**Chemung County Stormwater
Construction Inspection
Erosion and Sediment Control**

Project Name Barrington West Lot #54	Date 4-11-22
Location Royal Court Horseheads, NY	Permit # NYR11F212
Weather Conditions sunny	Entry Time: 11:45 am
On-Site Representative Present:	Exit Time: 11:54 am

PROJECT: Barrington West Lot #54
Town of Horseheads
Municipal Inspection
April 11, 2022

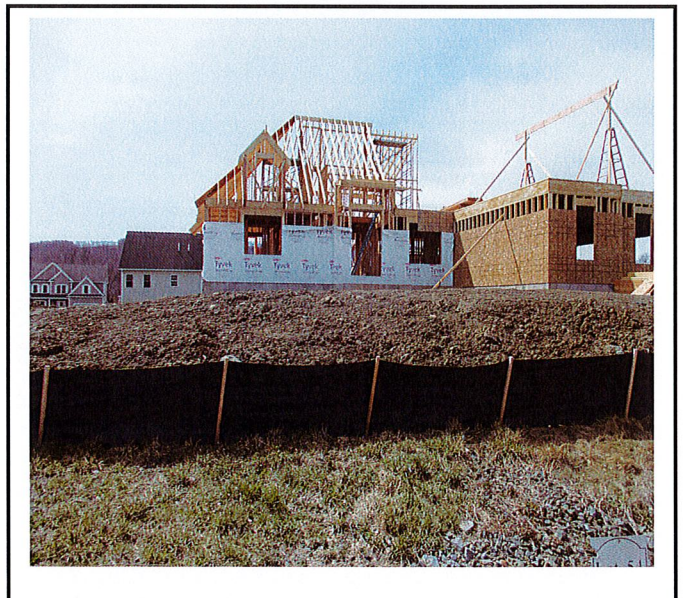
Soil is overtopping the silt fence. Remove soil and repair silt fence.

Silt fence not properly toed into the ground.

Drainage issues already a cause of concern.

Soil is not being actively disturbed at this time-stabilization required.
